EDGERTON PLANNING COMMISSION AGENDA
SESSION
Edgerton City Hall
December 13, 2016
7:00 PM

To: Edgerton Planning Commission
Fr: Kenneth Cook, AICP, CFM, Community Development Director
Re: Application FS2016-09 for Final Site Plan for Inland Port XIII, located south of 191st Street one-quarter mile east of Waverly Road.

Requested Action: Final Site Plan – Inland Port III, Logistics Park Kansas City - Southeast, Fourth Plat, Lot 3.

Inland Port XIII Final Development Plan Logistics Park Kansas City - Southeast, Fourth Plat, Lot 3

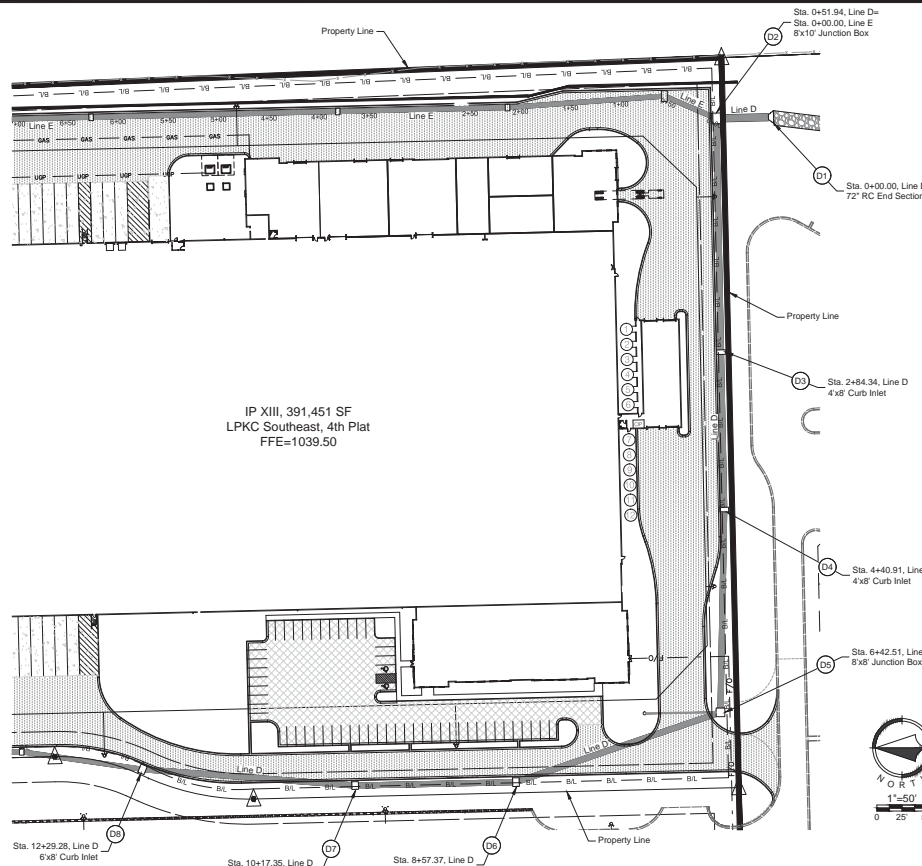
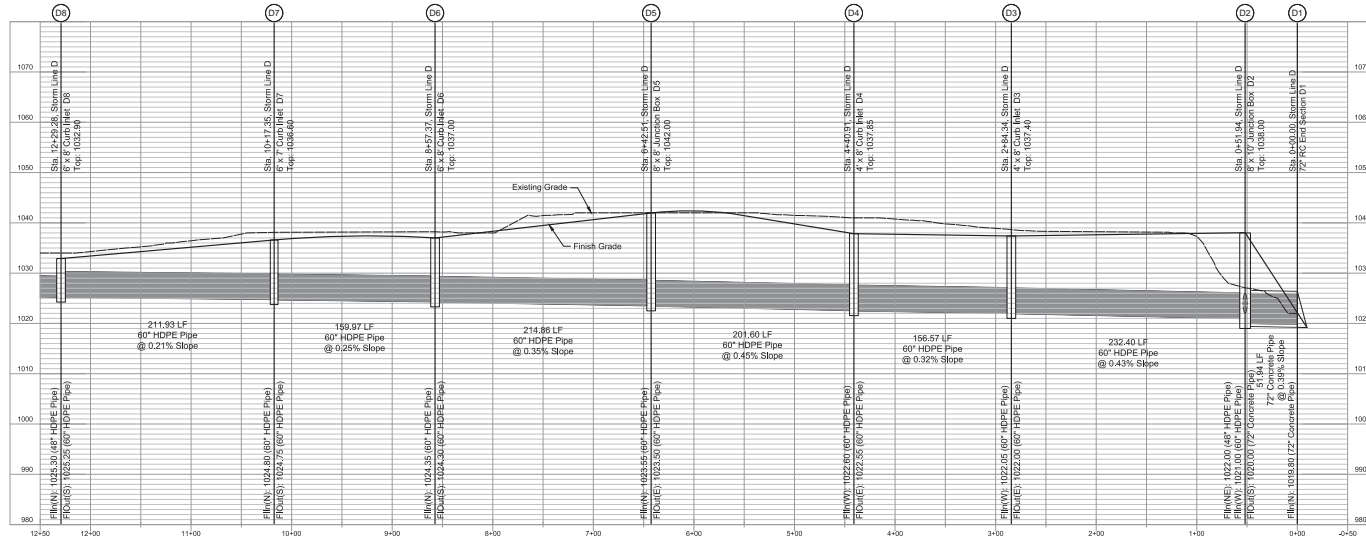
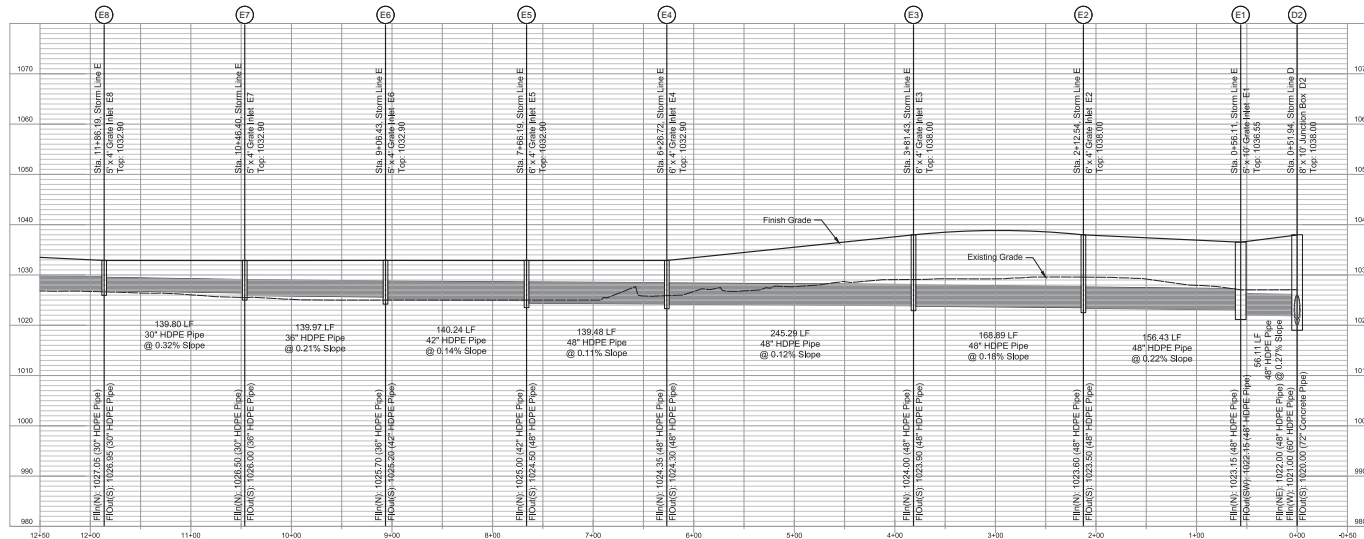
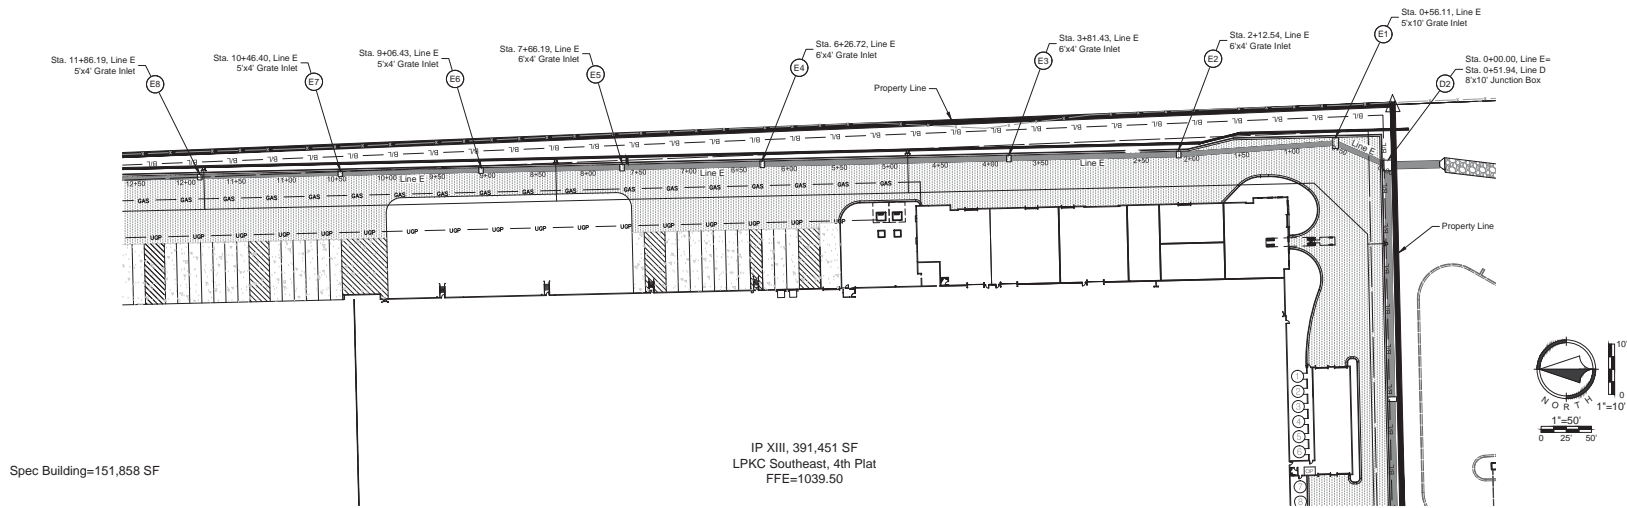
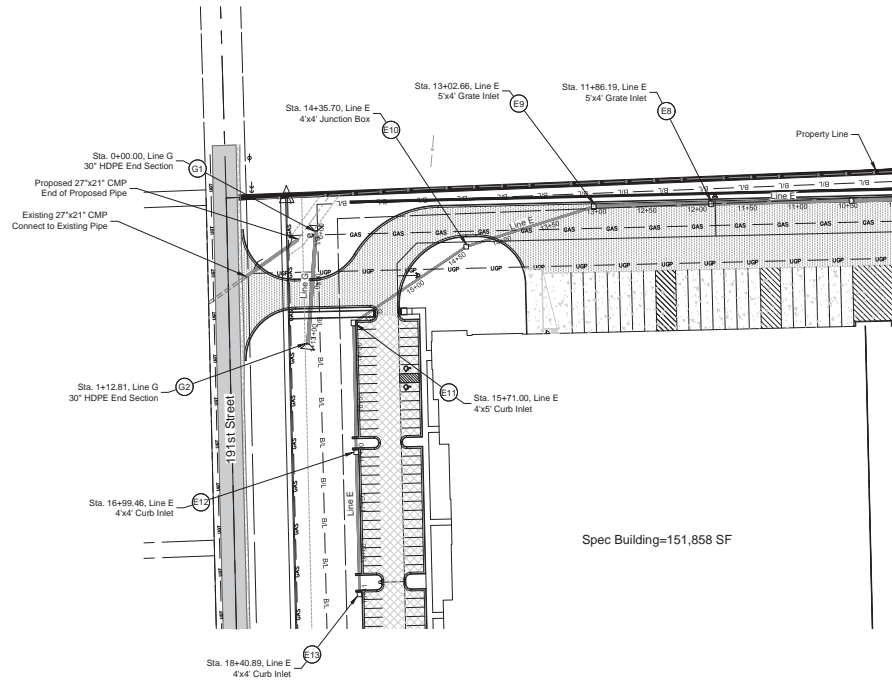
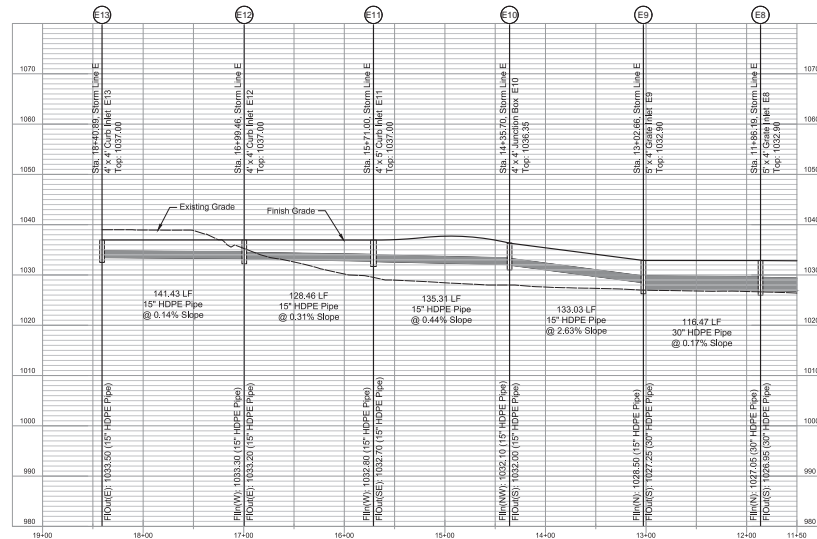
- *Two landscape plans have been submitted, second sheet is labeled a L02.*
 - *The proposed building orientation places dock doors facing west toward another building and east toward undeveloped ground. There is no proposed trailer storage areas in the parking lots. Therefore no additional landscaping and screening will need to be provided as design guidelines contained in 5.2 L-P Logistics Park District of Article 5 of the Unified Development Ordinances are not applicable.*

- *Please indicate right-of-way for 193rd Street on landscape plan sheets.*
 - *To the landscaping notes, please add text that states the proposed landscaping shall be installed so that when at full maturity it will not encroach into identified sight triangles.*

- *No timetable has been indicated for any of the planting.*
- *Please verify quantities on both landscaping plans as the quantities listed do not match those depicted.*

3. Parkway Buffer Requirements. *Identify the right-of-way for 191st Street on the landscape plans.*
4. Right-of-Way Buffer Width Requirements. *The buffer requirement is 10 feet. Identify the right-of-way for 191st Street on the landscape plans so the buffer width can be calculated.*

8. Dumpster and Compactor Screening. *Trash enclosures or screening for them is not shown.*
9. Fencing. *No fencing is shown.*
10. Alternative Landscape Plan. *Not applicable.*

A1.13
OVERALL FLOOR PLAN

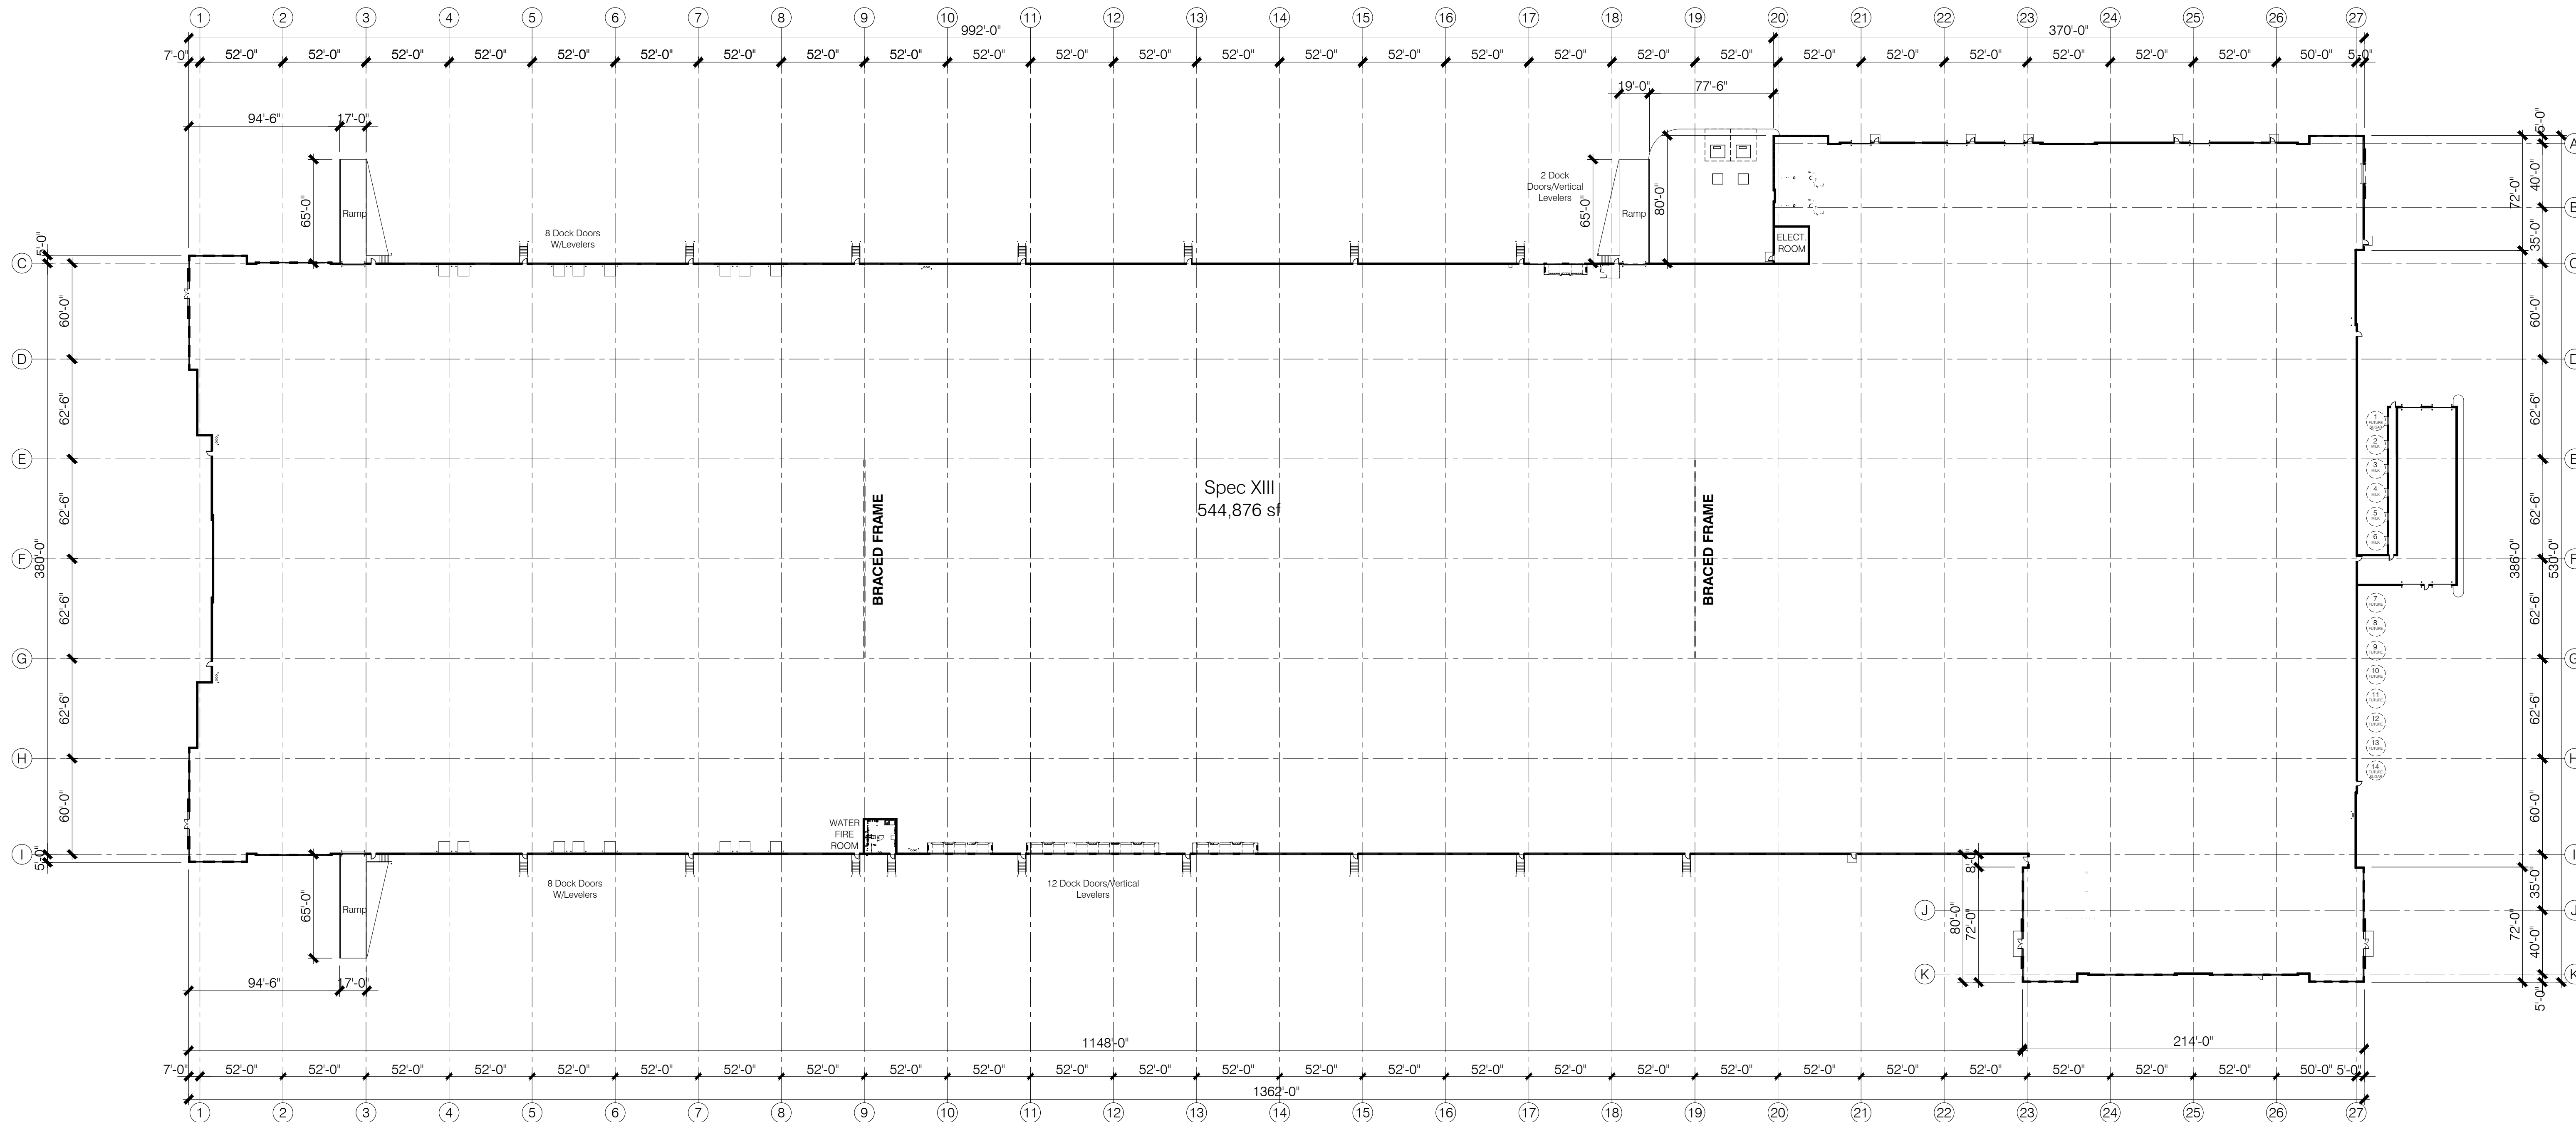
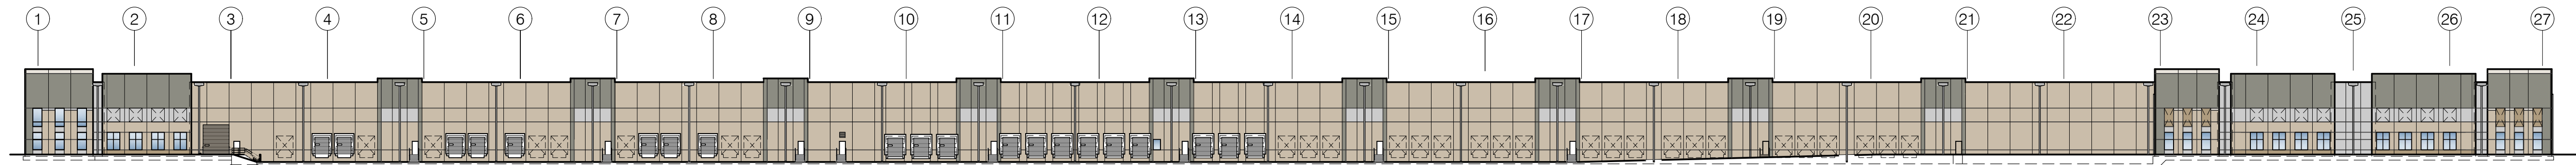
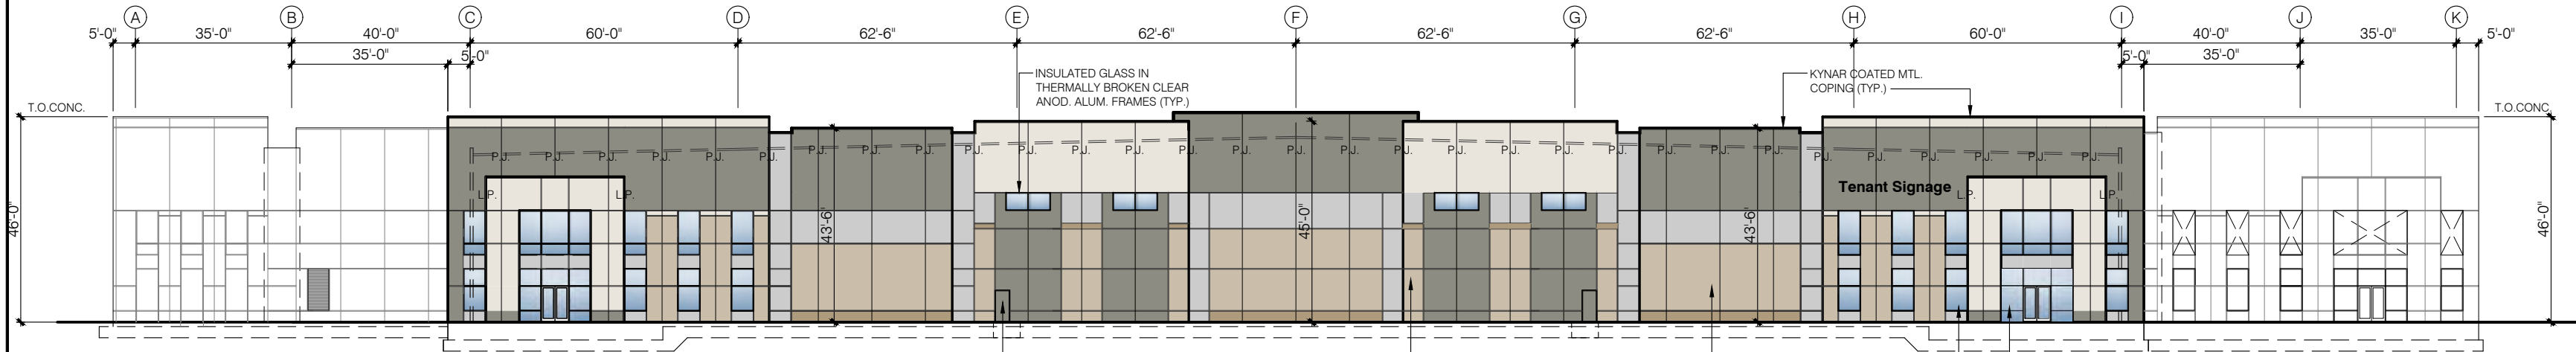
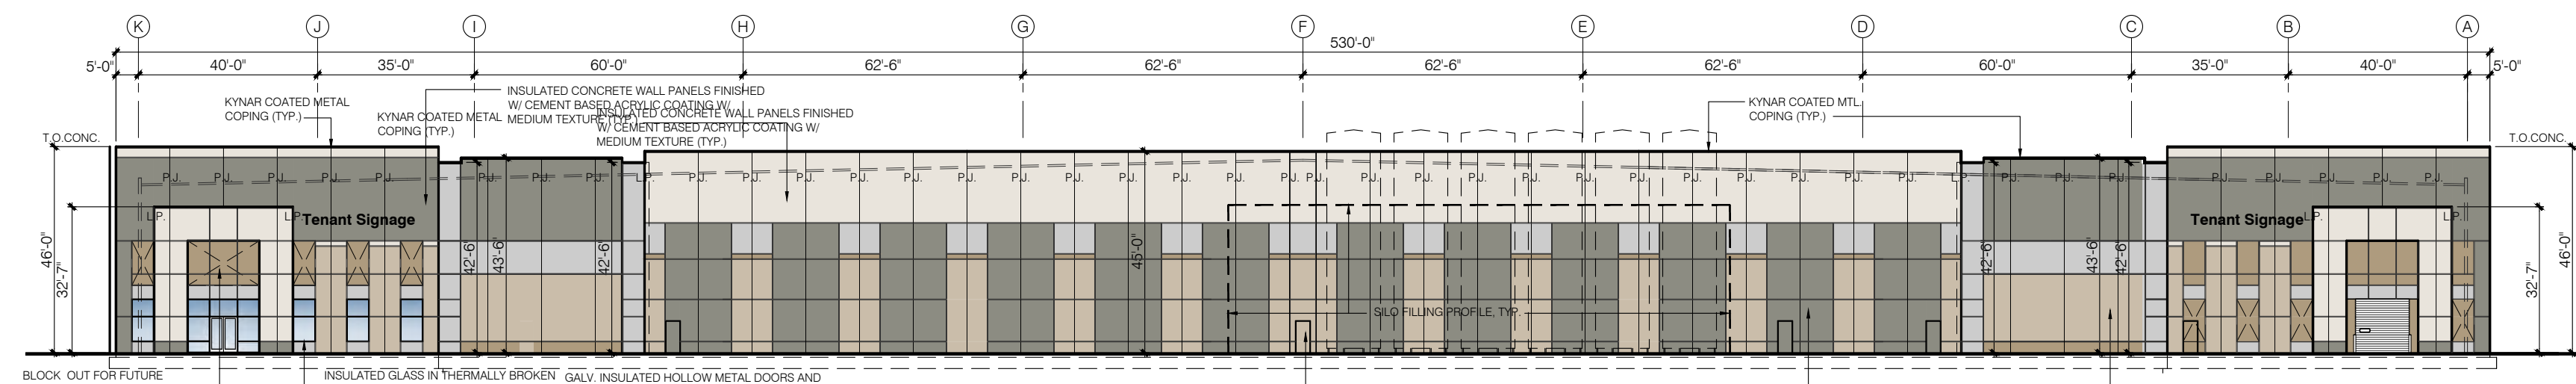
*The proposed elevations appear to be consistent with buildings approved and constructed in earlier LPKC phases. The North elevation of the building faces 191st Street, (public road right-of-way). The north and south elevations use vertical and horizontal articulation, windows, and color blocking to effectively break up building massing. The west and east façades again use vertical articulation, color blocking, and windows effectively, though the great lengths on these sides provide more opportunities for varying techniques than are taken advantage of in the design. **Final Site Plan Complies.***

*The East, West and South elevations (walls) do not face public rights-of-way nor does city regulations require horizontal articulation for elevations (walls) that with loading docks. **Building Elevations for Final Site Plan Comply.***
